City of Sandy

Planning Commission Meeting

Meeting Date: Monday, February 27, 2023

- 8.2. 22-031 DR/VAR/TREE State Street Homes Mixed-Use Development (Quasi-Judicial) 274 - 525
[22-031 DR/VAR/TREE State Street Homes Mixed-Use Development - Pdf](#)
[Exhibit A Land Use Applications](#)
[Exhibit B Narrative](#)
[Exhibit C Plan Set](#)
[Exhibit D and E Lighting Plans and Cut-Sheets](#)
[Exhibit F Stormwater Report](#)
[Exhibit G Transportation Analysis Letter](#)
[Exhibit H Arborist Report](#)
[Exhibit I ODOT Memo](#)
[Exhibit J Indenture of Access](#)
[Exhibit K and L Easements](#)
[Exhibit M Parks Comments](#)
[Exhibit N Fire Marshal Comments](#)
[Exhibit O ODOT comments](#)
[Exhibit P City Transportation Engineer DKS Comments](#)
[Exhibit Q PW Comments](#)
[Exhibit R Third Party Arborist Review](#)
[Exhibit S ODOT Comments State Street Homes pre-app](#)
[Exhibit T Email from ODOT](#)
[Exhibit U Sandy Multi-Family Site Plan Revisions \(rcvd Feb 9, 2023\)](#)
[Exhibit V Dennis Petross Public Comments \(received February 14 2023\)](#)

1 TRASH ENCLOSURE

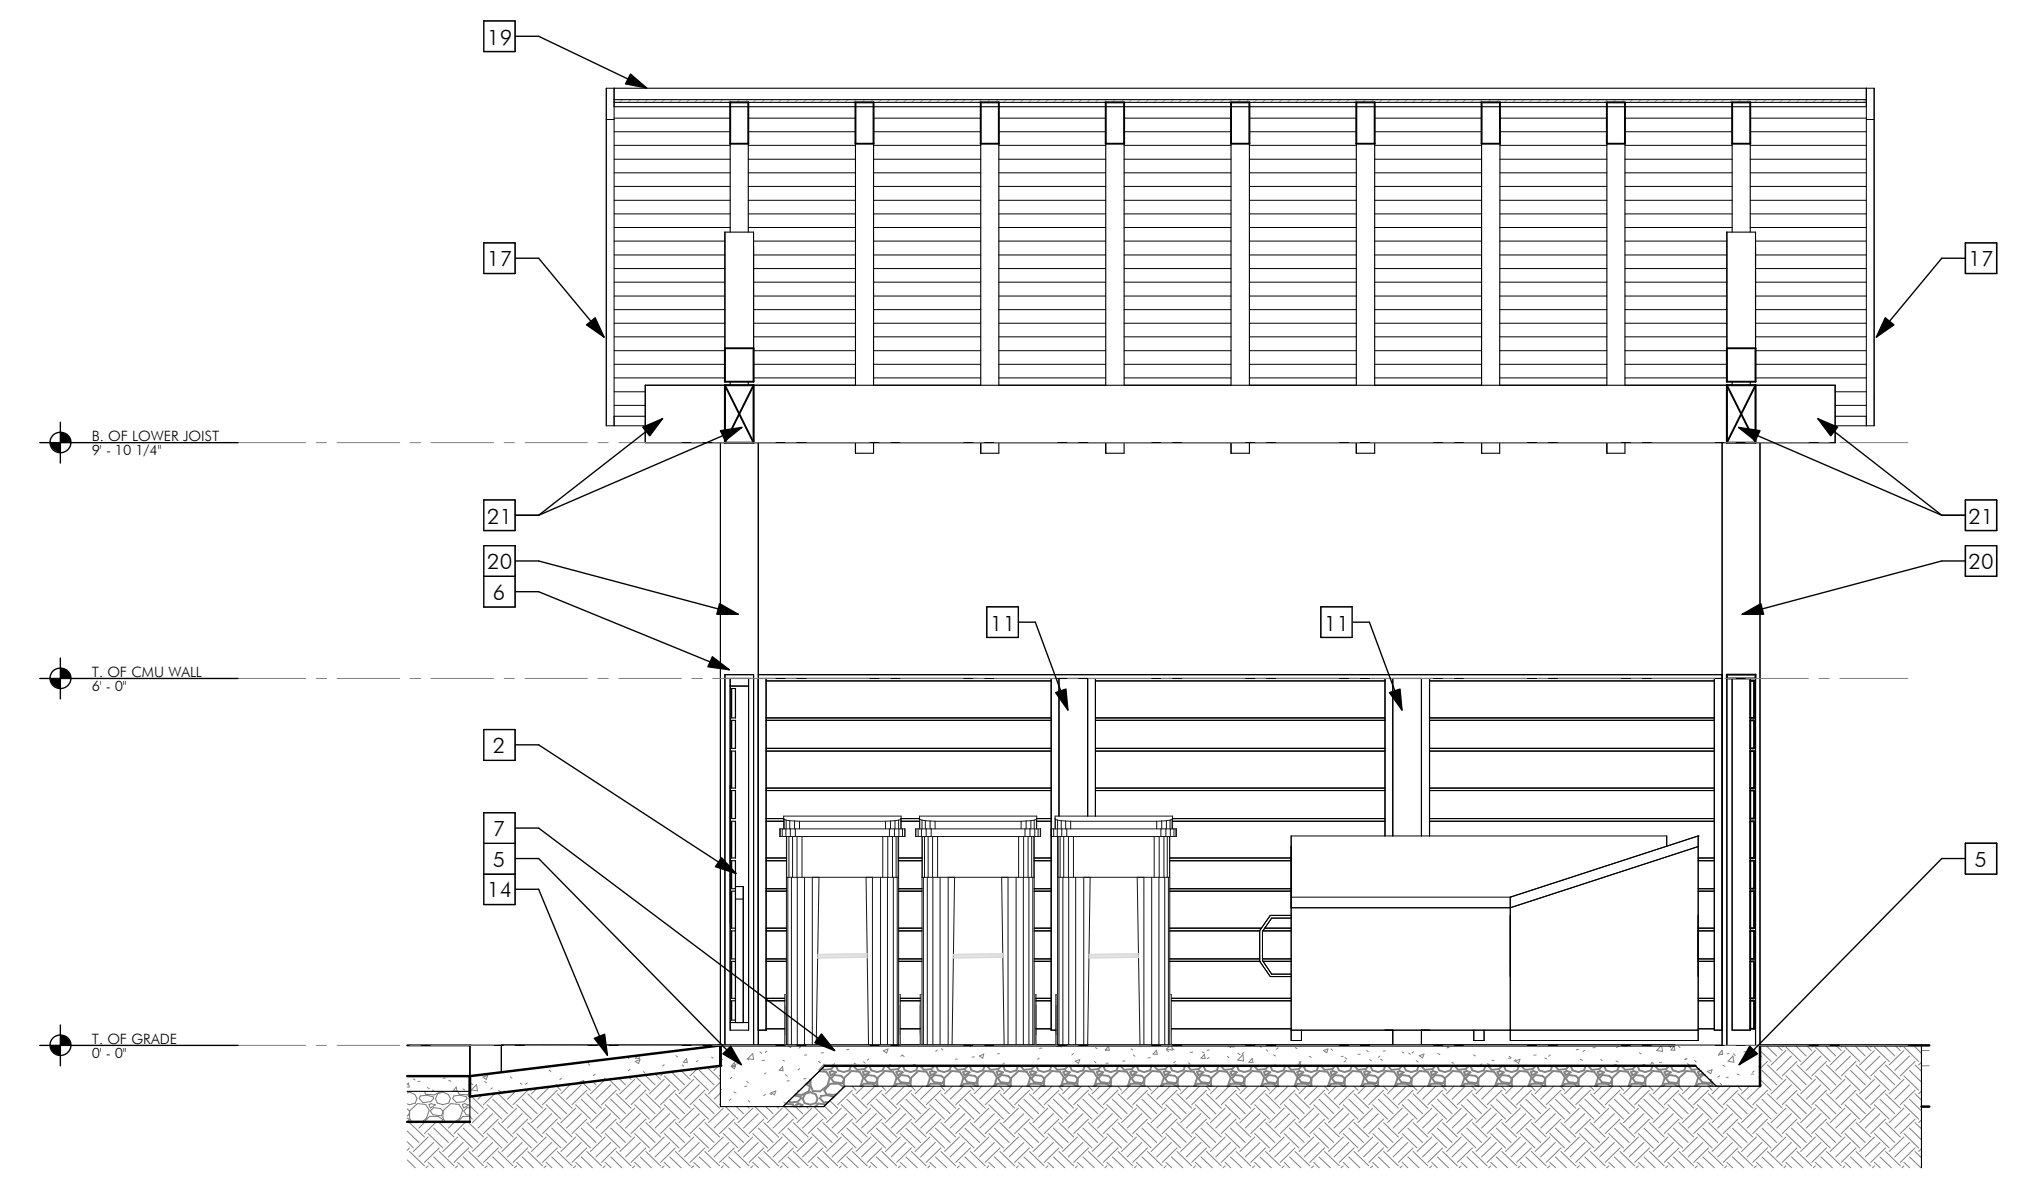
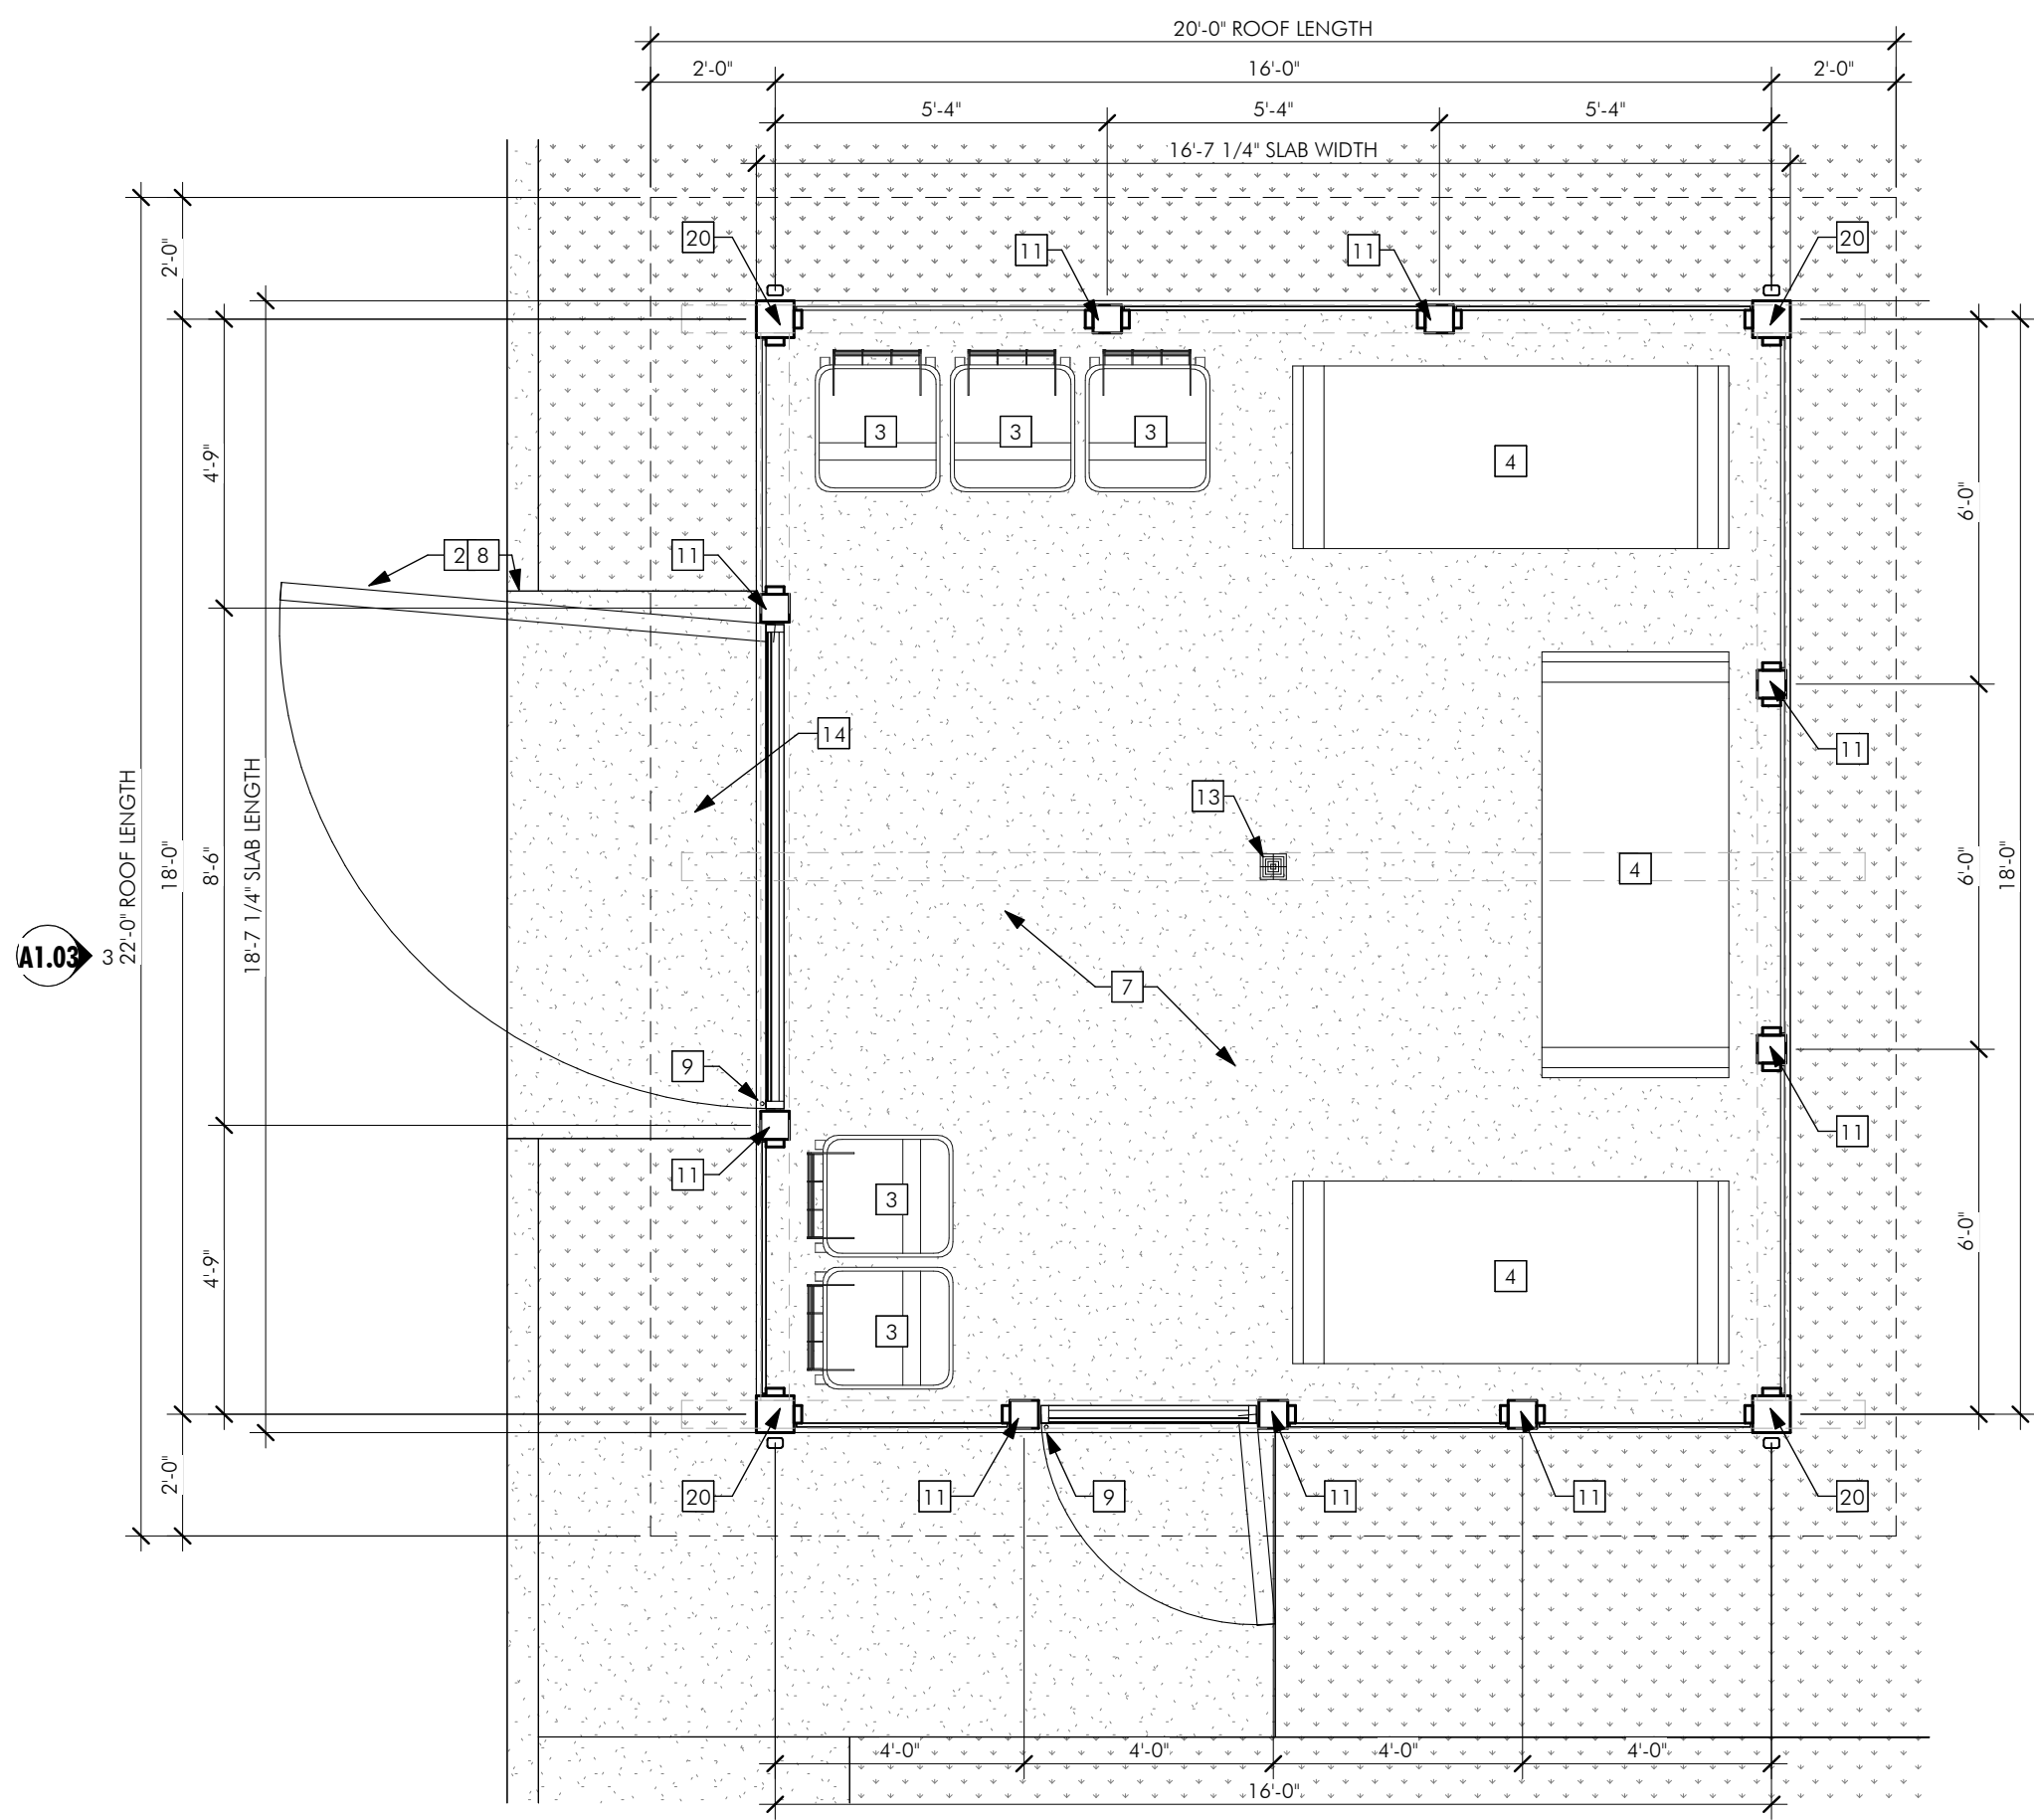
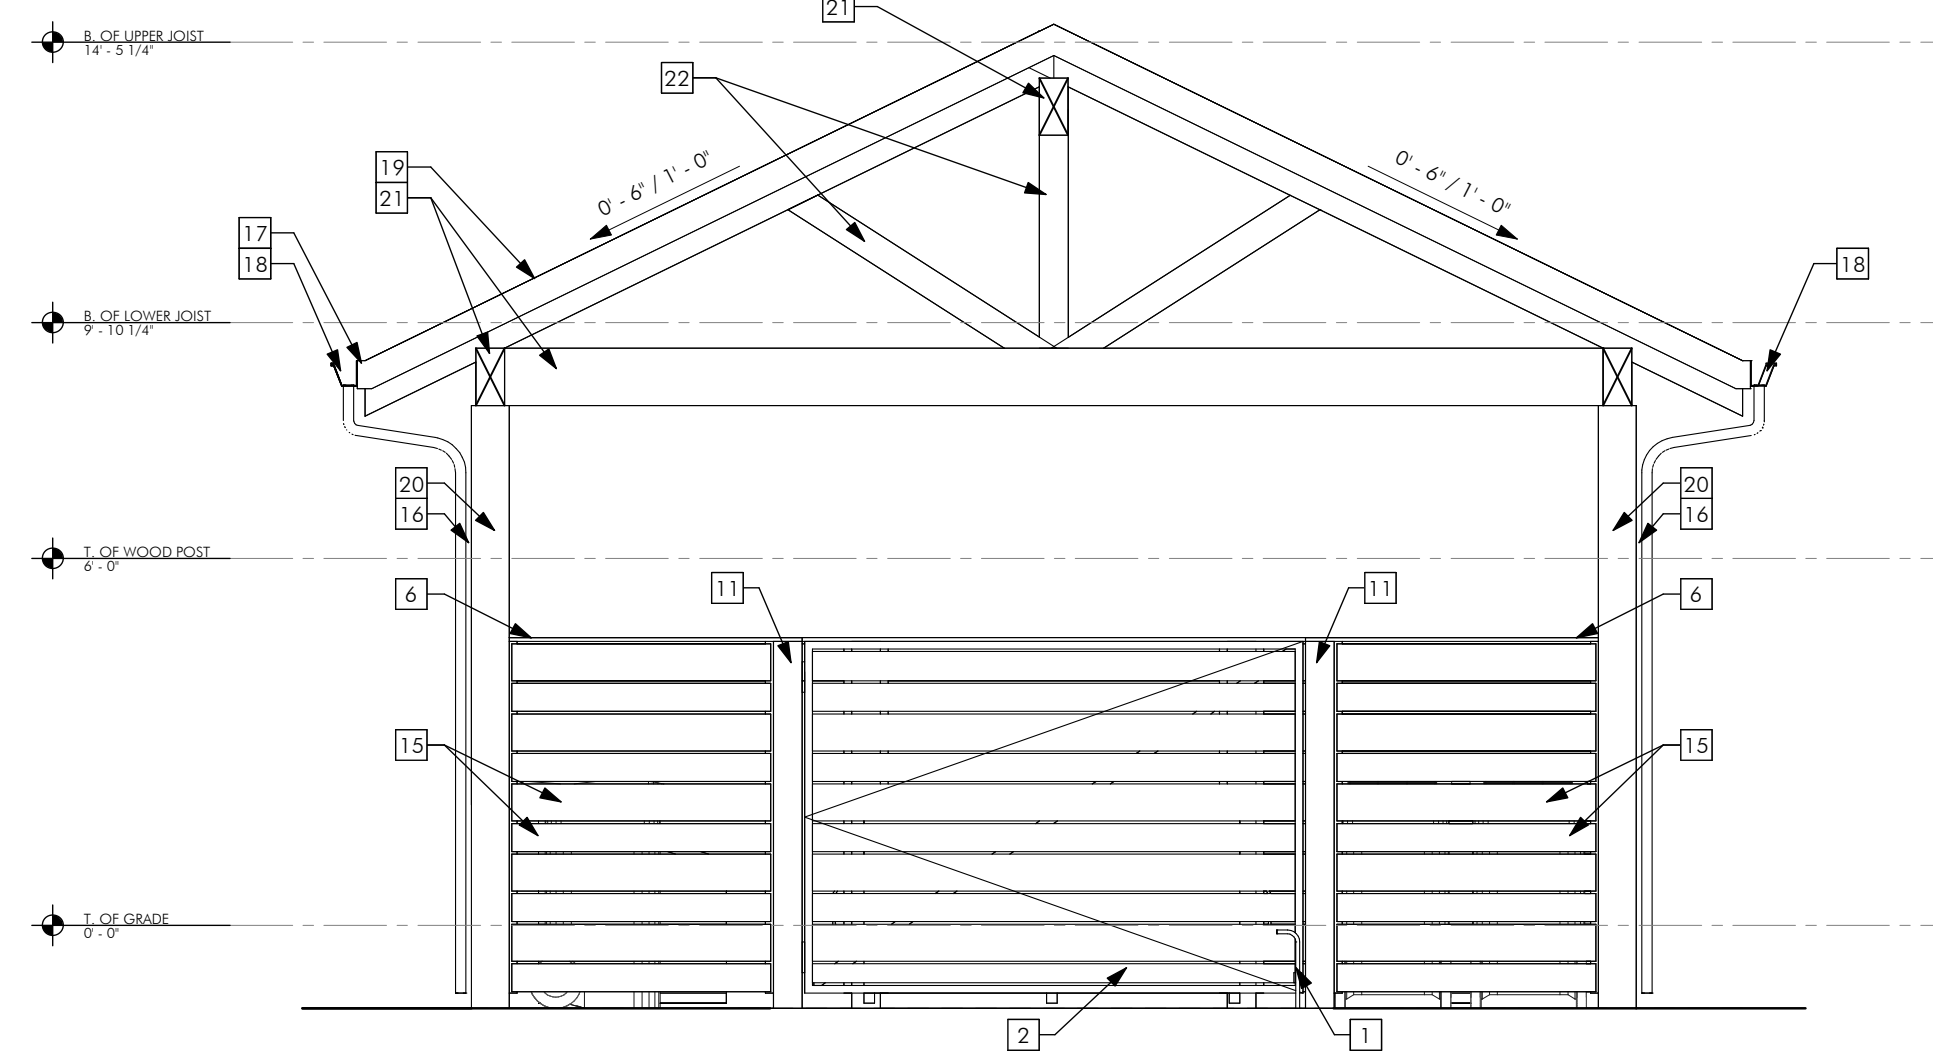
40. Section 17.90.120(J.4) contains standards for trash collection and recycling areas. The applicant proposes a screened garbage and recycling area to the east of the proposed mixed-use building. The submitted Trash Enclosure Elevations (Exhibit C, Sheet A1.03) detail a covered structure with a gabled roof and a 6-foot-tall wall on all four sides designed to match the primary building in compliance with the code. The wall is proposed to be alternating 1-inch by 6-inch and 1-inch by 8-inch horizontal boards with a 1/2-inch gap between each and painted “Gropius Gray” to match the main building with 6-inch by 6-inch pressure treated wood posts. The front (west) and side (south) walls contain gates for access.
